NORTH SYDNEY COUNCIL REPORTS

NSLPP MEETING HELD ON 05/10/22

ADDRESS/WARD: 48 Edward Street, North Sydney

PROPOSAL: Alterations and additions to dwelling

Figure 1E - Amended East (Street) Elevation

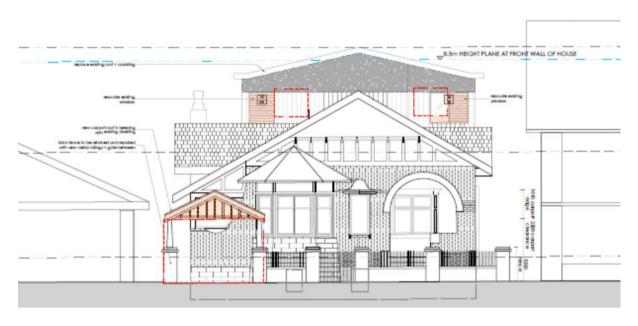
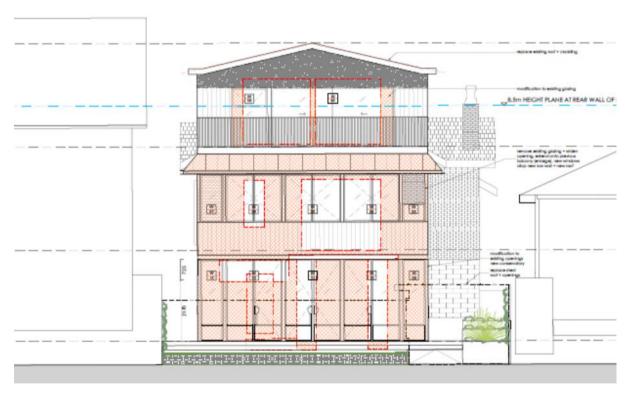
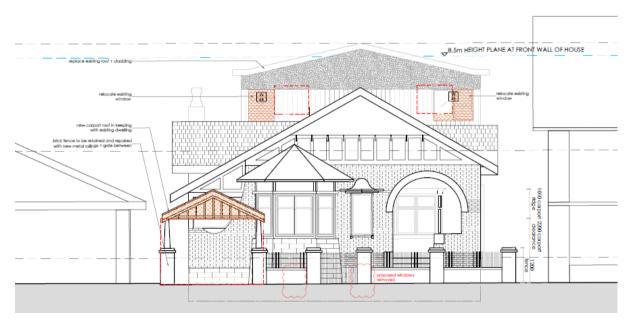
The application has since been amended in response to Council's recommendations in the RFI letter dated 8 July 2022. The applicant submitted amended architectural plans which addressed Council's recommendations. The amended proposal is reflected in the following images:

The amended architectural plans have adequately addressed the Conservations Planner's requests, and are considered to improve the proposed development in relation to heritage impacts. As requested by the Conservation Planner, the proposal has been amended to retain the existing period bathroom, recess new windows at the lower ground floor into the existing sandstone base, and delete the new window openings in the front, eastern elevation, and the skylight proposed to the front bedroom.
